From: [REDACTED]
To: [East Anglia ONE North](#)
Subject: Written Representations of Suffolk Energy Action Coalition (SEAC) in relation to East Anglia ONE North Offshore Windfarm – Planning Inspectorate Reference: EN010077 [TH-THL.FID118736201]
Date: 29 October 2020 10:48:58
Attachments: [SEAC Summary of Written Representations EA1N_THL_144672707_1.pdf](#)
[SEAC Written Representations EA1N_THL_144672541_1.pdf](#)

Written Representations of Suffolk Energy Action Coalition

in relation to East Anglia ONE North Offshore Windfarm - Planning Inspectorate Reference: EN010077

Figure 3: Areas shown by Figure 2 of the NTS which sets out the 'onshore development area'

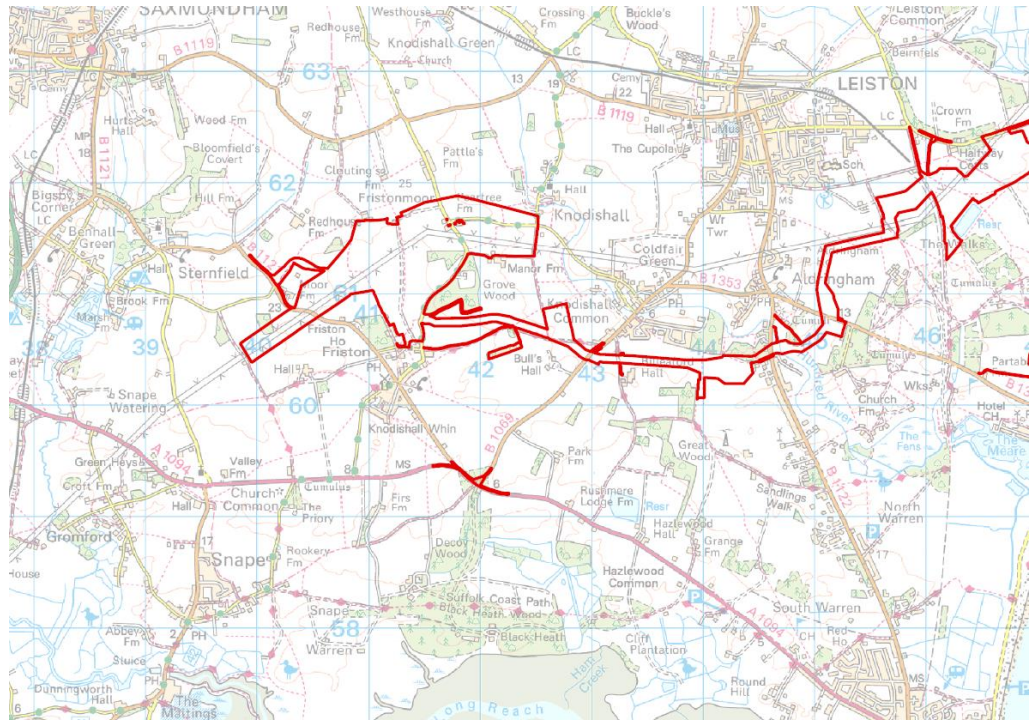
- 4.2.21 This definition and associated visual representation as provided in Figure 2 NTS is an incorrect representation of the true extent of the onshore development area as it does not detail the road network (in particular the B1121) required to access the proposed onshore substation(s) or the village of Friston which is adjacent to the onshore substation(s) and through which the B1121 runs.

- 4.2.22 The incorrect representation of the 'onshore development area', and in particular, the exclusion of the B1121 and Friston renders understanding of the baseline and subsequent impacts on these receptors inadequate. This fundamental flaw has resulted in a failure of the ES to adequately consider a number of key impacts of the onshore development, thus making the ES a document that is unfit for purpose. Further objections as a result of this significant error are discussed in detail in the objections set out below.

- 6.1.1 As set out in Representation 2, the 'onshore development area' is defined within the NTS as 'the area in which the landfall, onshore cable corridor, onshore substation, landscaping and ecological mitigation areas, temporary construction facilities (such as access road and construction consolidation sites), and the National Grid Infrastructure will be located'. This definition and associated visual representation as provided in Figure 2 of the NTS (a copy of the applicable area of which is replicated below in Figure 3), is an inadequate representation of the true extent of the onshore development area as it does not detail the road network (in particular the B1121) required to access the proposed onshore substation(s) or the village of Friston which is adjacent to the onshore substation(s) and through which the B1121 runs.

Figure 4: OLMP Illustrative Plan

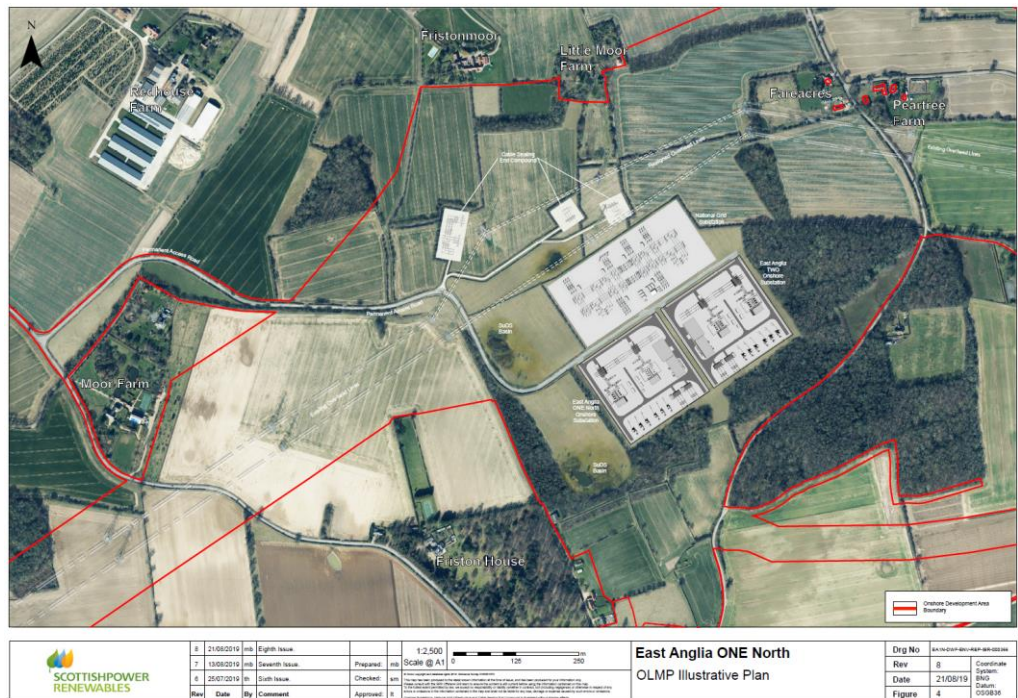
6.2.5 The OMLP Illustrative Plan (the relevant section of which is replicated below in Figure 4) shows a 'Permanent Access Road' leading from the B1121 to the substation(s). This road does not currently exist and will need to be constructed as part of EA1N. The permanent road will be up to 8m wide and 1700m long.

6.2.6 In order to construct this road, HGVs and other vehicles will have to travel on the B1121, which runs through the village of Friston. This contradicts the statement discussed below that HGVs will not travel on the B1121 and supports the need for air quality and traffic and transport baseline data to be collected, and subsequent monitoring and mitigation strategies developed for the village of Friston.

6.2.9 Failure to consider the construction and operation of the Permanent Access Road to the substation is a significant failing of the ES. The construction of the Permanent Access Road will have many environmental and socio-economic impacts, including increased traffic and transport travelling on the B1121, including HGVs, which will result in air quality impacts. Removal of agricultural land to make way for the road could lead to habitat fragmentation and biodiversity loss which has not been assessed.

Figure 5: Screenshot taken from Google Maps showing the local road network around the site of the proposed onshore substation(s).

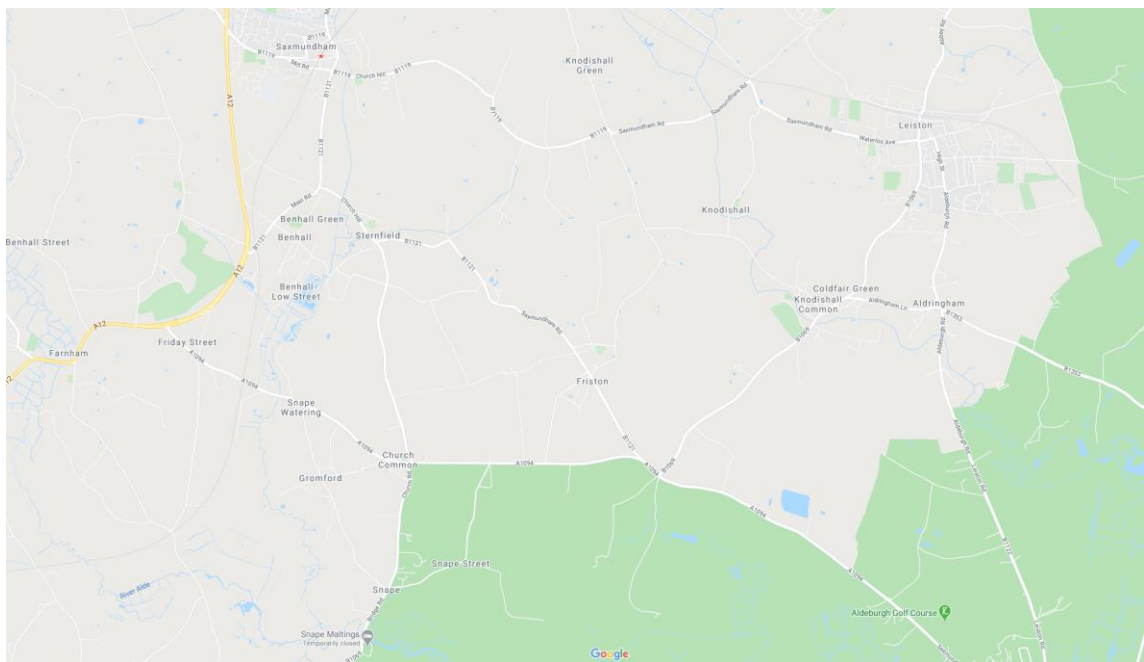
- 6.2.11 Figure 5, above, shows that based on these commitments, HGV access to the 'permanent access road' and to the site of the substation(s) is not possible.
